Access Compliance Report

Public Rights-of-Way

(Curb Ramps)

Intersection ID: 9490	Main Street: BARRINGTON_DR	Cross Street: CRAFTSBURY_DR	Location: S
ADA ID: 85839F196C30	Ramp Type: Perp	Initial Pass/Fail: Fail	Overall Compliance: No
Severity Score: 8.75			
Codes/Mitigation Info/Possible Solution		Field Measurements/Component Compliance

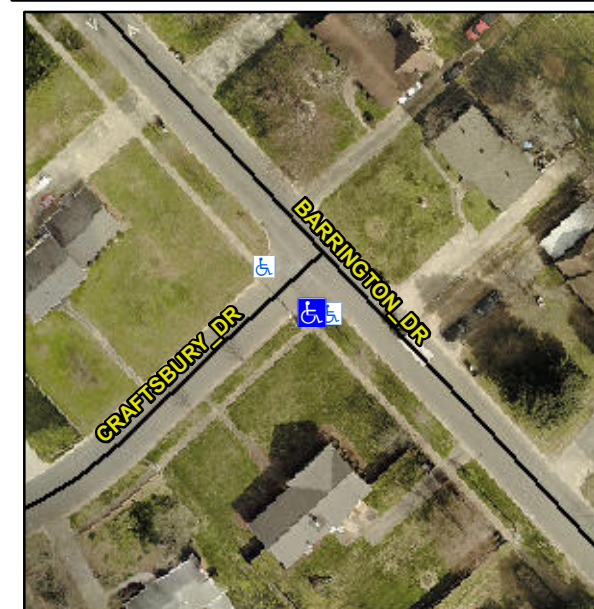
Not Found, R304.5.1

Compliance	Description	Data	Compliance	Description	Data
N/A	Ramp Length (in)	65.5	Yes	Ramp Slope (%)	7.7
No	Ramp Width (in)	45.0	Yes	Ramp XSlope (%)	1.8
N/A	Flare Type LT	N/A	N/A	Flare Type RT	N/A
N/A	Flare Slope LT (%)	N/A	N/A	Flare Slope RT (%)	N/A
N/A	Flare Traversable LT?	N/A	N/A	Flare Traversable RT?	N/A
N/A	Landing Length (in)	N/A	N/A	DWS Provided?	N/A
N/A	Landing Width (in)	N/A	N/A	DWS Contrast?	N/A
N/A	Landing Slope (%)	N/A	N/A	DWS Length (in)	N/A
N/A	Landing X Slope (%)	N/A	N/A	DWS Full Width?	N/A
N/A	Landing Curb? (Y/N)	N/A	N/A	DWS Offset (in)	N/A
N/A	Shared Landing?	N/A			
N/A	Gutter Ponding?	N/A	N/A	Gutter Slope (%)	N/A
N/A	Gutter Lip Ht (in)	N/A	N/A	Gutter X Slope (%)	N/A
N/A	Painted X Walk1?	No	N/A	Painted X Walk2?	N/A
	X Walk 1 Direction	To NW		X Walk 2 Direction	N/A
N/A	X Walk 1 Width (in)	N/A	N/A	X Walk 2 Width (in)	N/A
	X Walk 1 Slope (%)	0.1		X Walk 2 Slope (%)	N/A
	X Walk 1 X Slope (%)	0.7		X Walk 2 X Slope (%)	N/A

Remove & Replace Entire Ramp.
